Submission to the Office of Independent Planning Commission of NSW (IPC)

Re: Objection to Greenwich Hospital Stage 2 (Concept proposal SSD-8699-Mod-1 and Detailed Design SSD13610238)

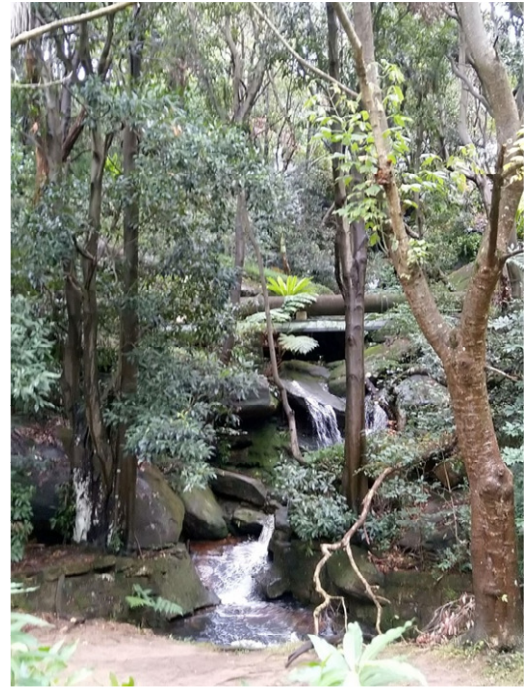
West side: It seems from BB stormwater management report that most of the stormwater from site, (except for that part of site falling to St Vincents Road) is collected in a 675 diameter pipe running below the through-road, then piped steeply down to join the 750 diameter pipe from River Rd. It then falls over a rock waterfall on the Hammondcare site, on the west side, at about contour 26.

Given the increase in impervious areas on the site, during heavy downpours there would be a significant increase in volume of water falling into the rock waterfall and pool at its base, on site. It is considered that some measures should be incorporated to modify or slow this flow. The new hospital large rainwater tanks will not assist during heavy downpours, because the surrounding land will become saturated and the tanks will simply overflow.

The splashing onto rocks at the end of the 750 diameter pipe will exacerbate further the moist weedy nature of the area, and it is highly likely that downstream damage to rock pools and erosion to Gore Creek may result.

- To plan for collection and pumping of sediment laden water /excavation material so as not to cause sediment escape
- To incorporate measures to modify or slow the flow of stormwater to reduce downstream damage and adverse environmental impacts
